Subject: OU-2 Remedial Design Revisions
NYSEG Cortland-Homer Former MGP Site
Site No. 7-12-005

On behalf of NYSEG, please find enclosed, revised final Design Drawings and Technical Specifications associated with the April 2020 Remedial Design Report (Remedial Design) for Operable Unit No. 2 (OU-2) of the NYSEG Cortland-Homer Former Manufactured Gas Plant (MGP) site located in Homer, New York (the site).

**AREA 2 RESTORATION PLAN
(STA.0+00 - STA.3+50)**

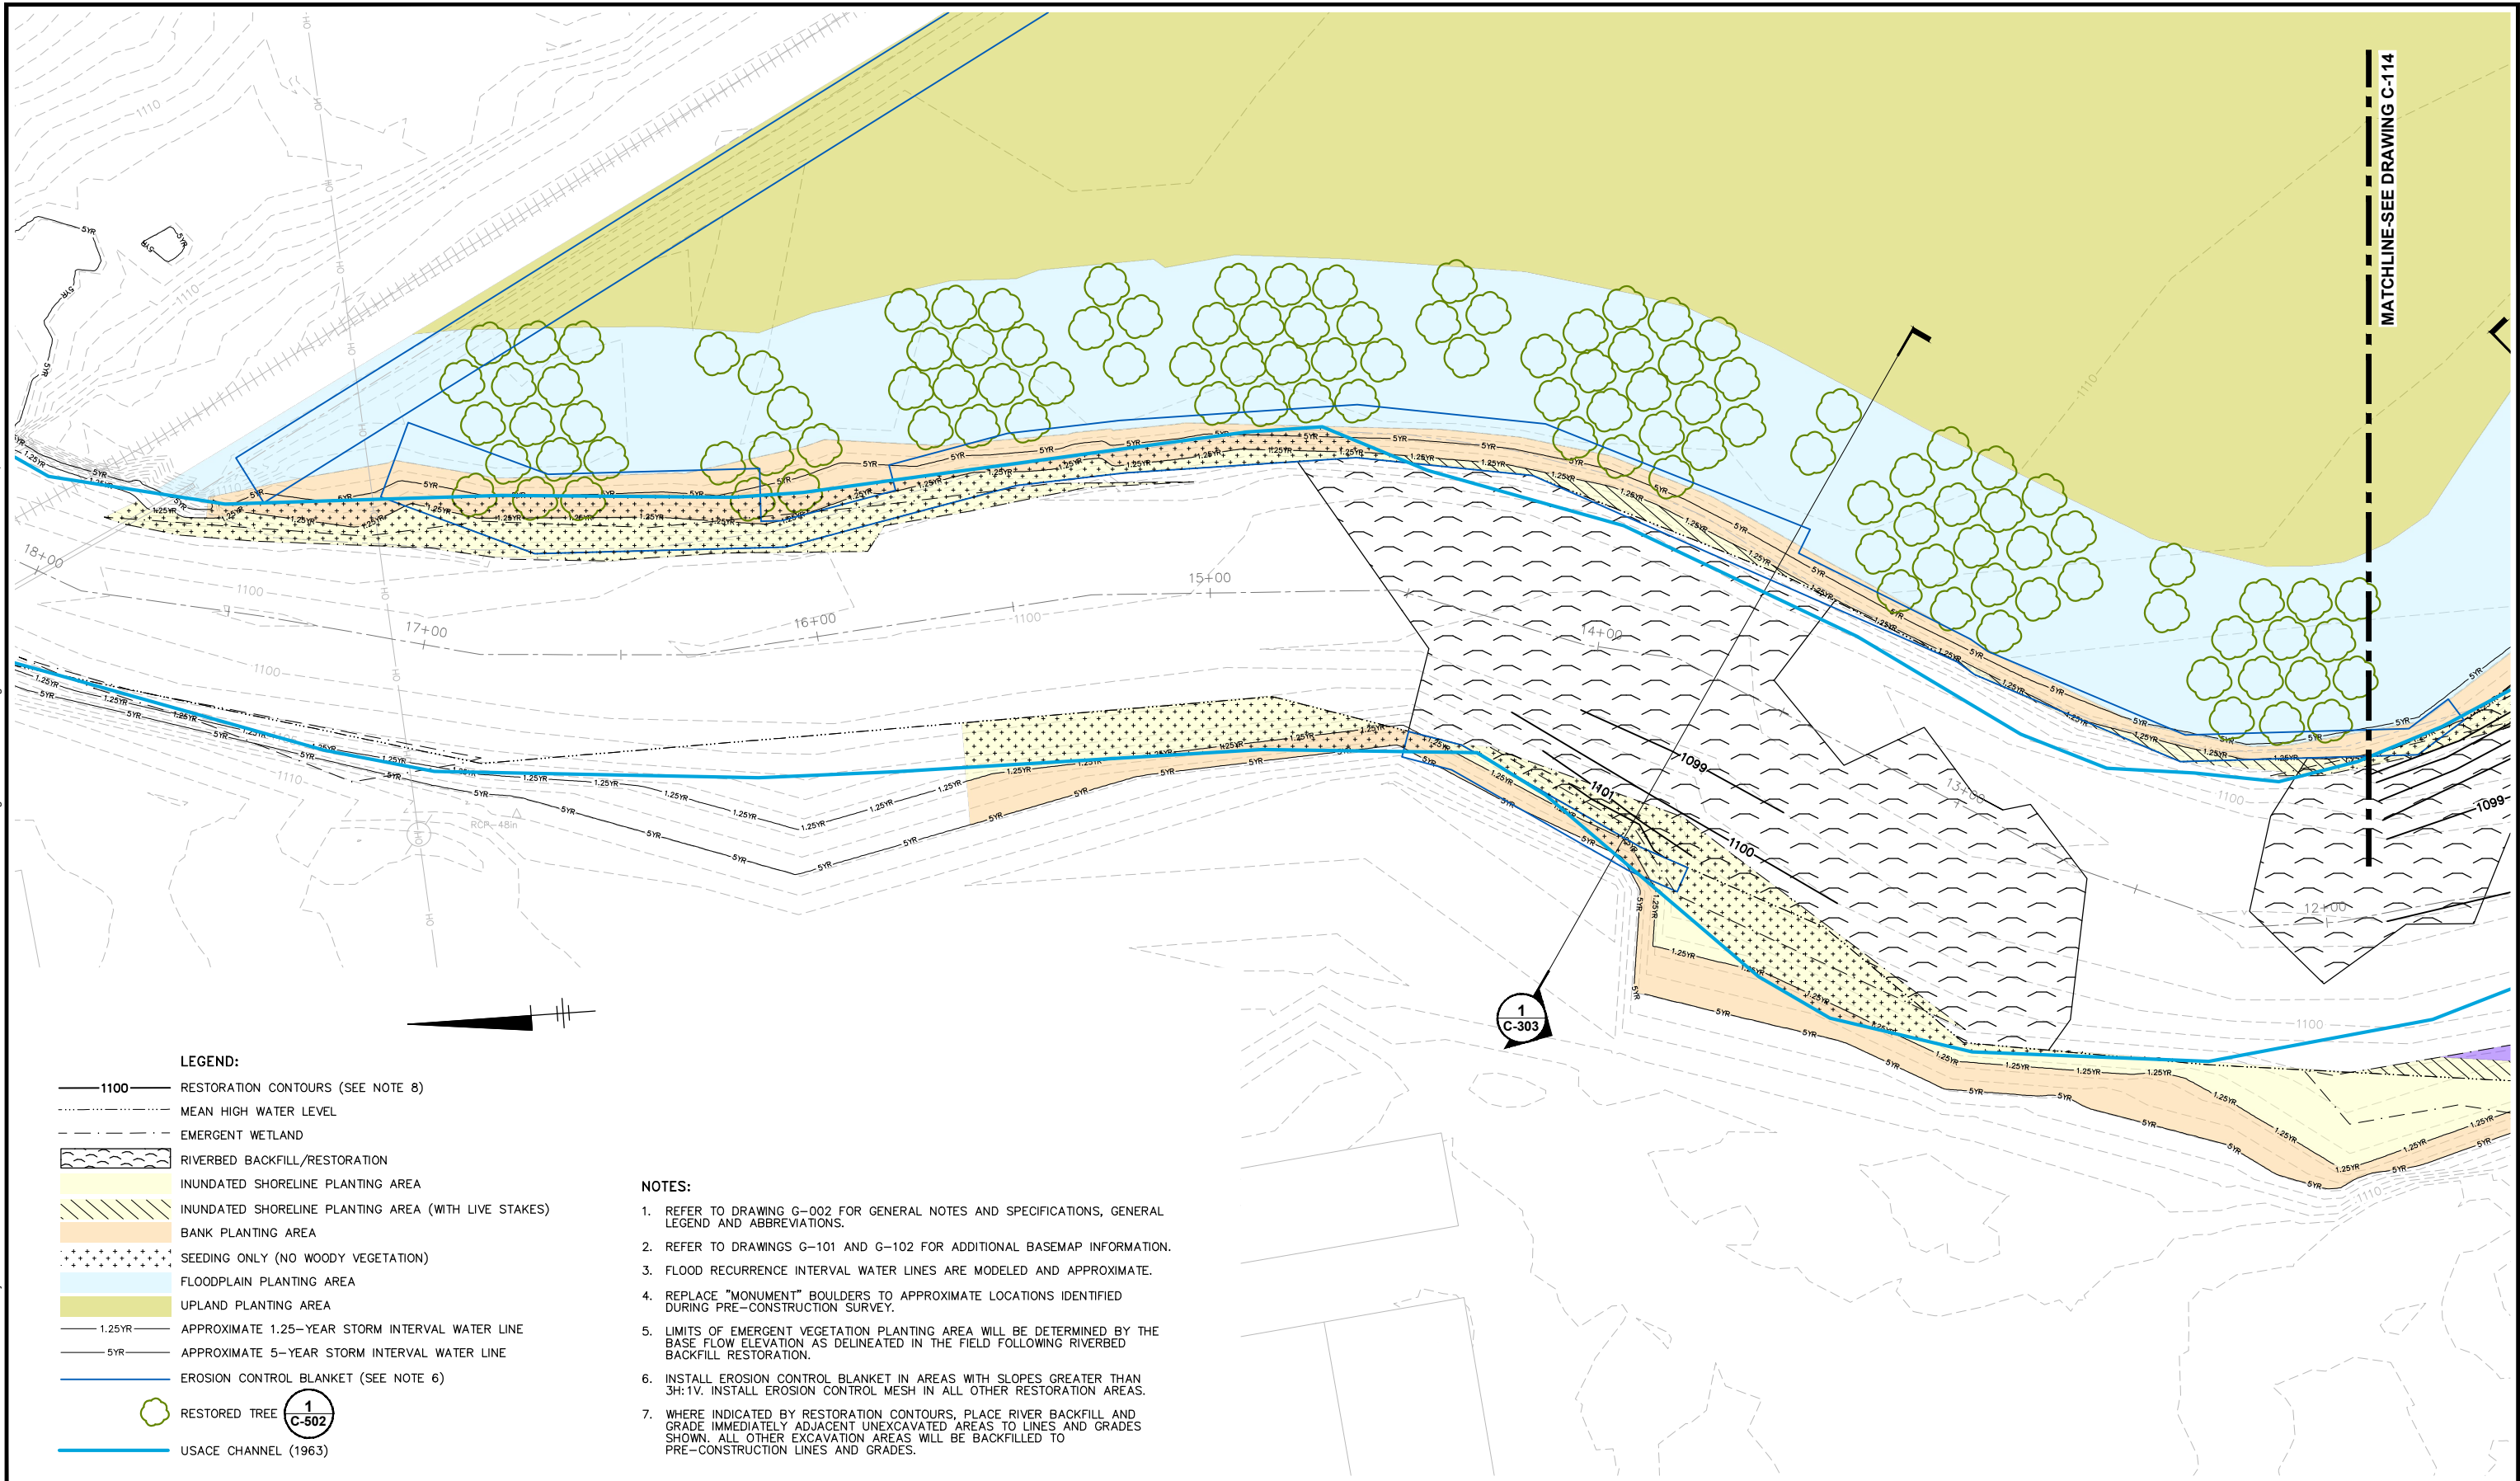
- Design Drawings C-112 to C-114, C-303, and C-304 – In response to NYSDEC comments during the Article 16 permit process, the riverbed and riverbank restoration elevations at Area 2 are revised to be consistent with river elevations following completion of the United States Army Corps of Engineers (USACE) 1963 Cortland Flood Control Project. Additionally, per NYSDEC's request, woody vegetation will not be installed within the channel limits.

**AREA 1 SHEET PILE PROFILE
(STA. 55+82 TO STA. 47+82)**

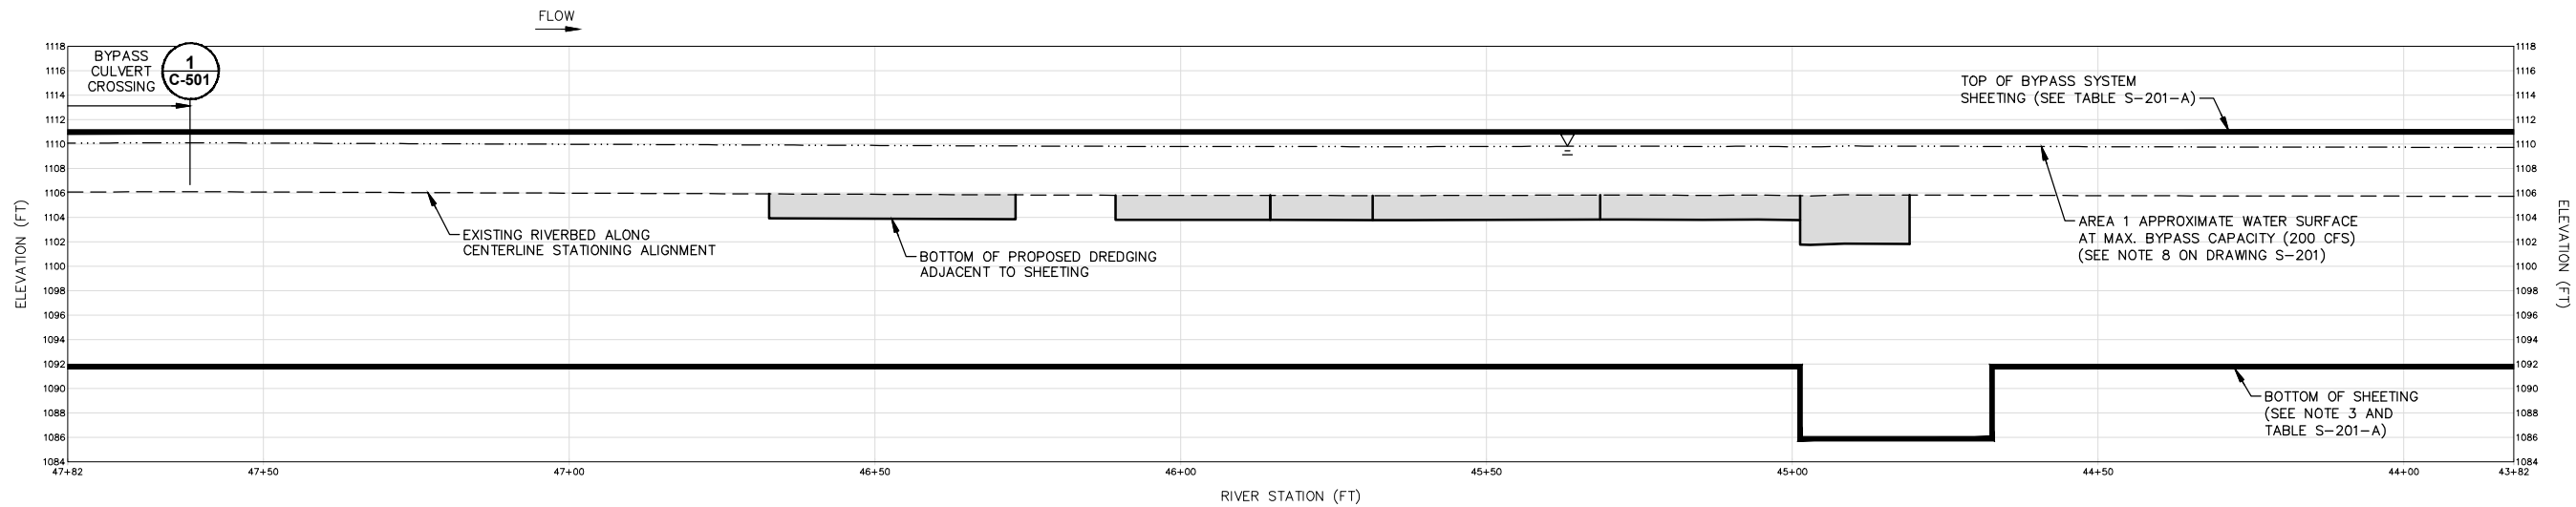
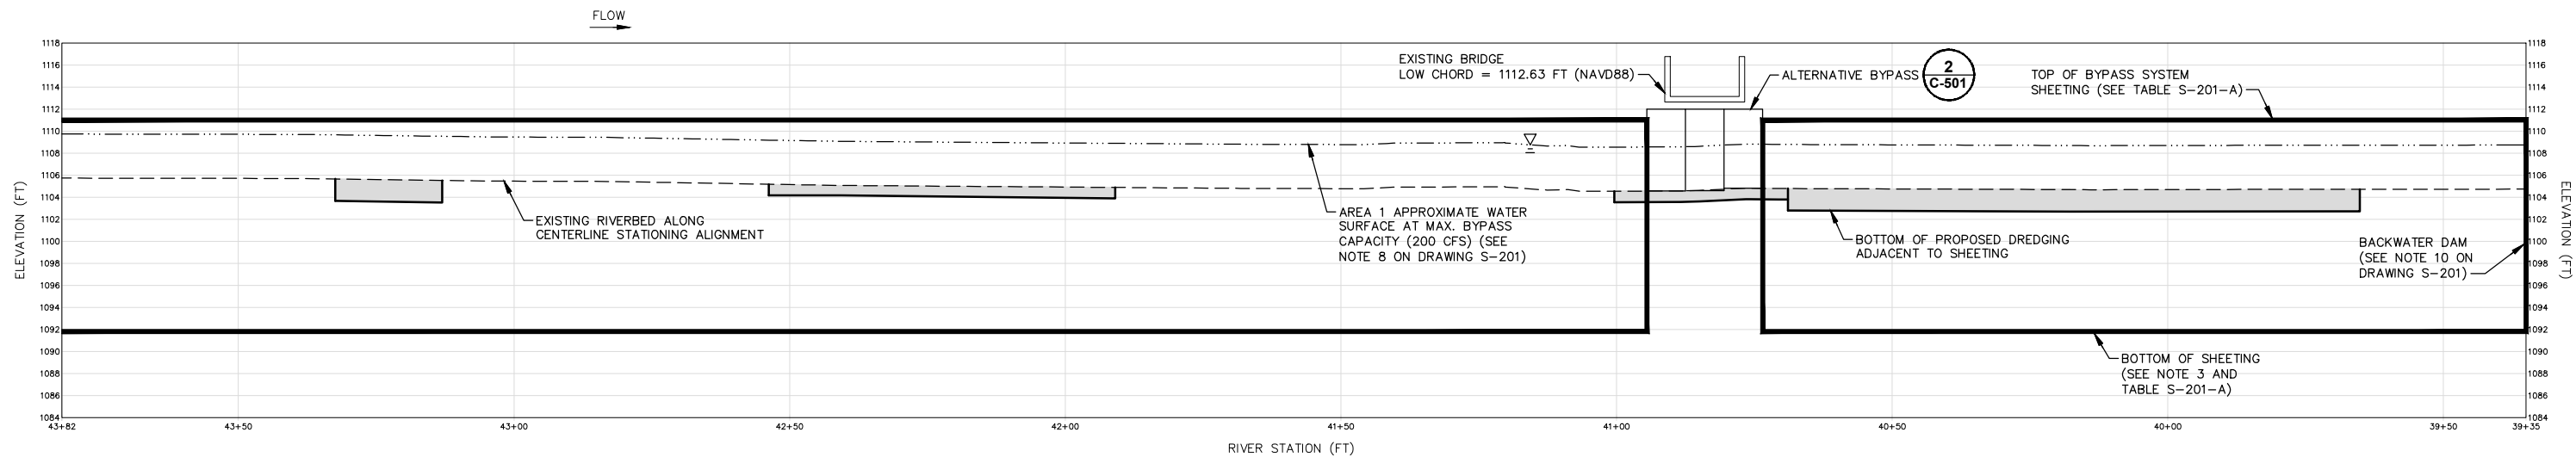
- Design Drawings C-504A through C-505 – Restoration planting tables are revised to include NYSDEC-approved tree species, as indicated in the WQC.
- Design Drawing S-201 – The minimum required sheet pile section modulus is corrected.
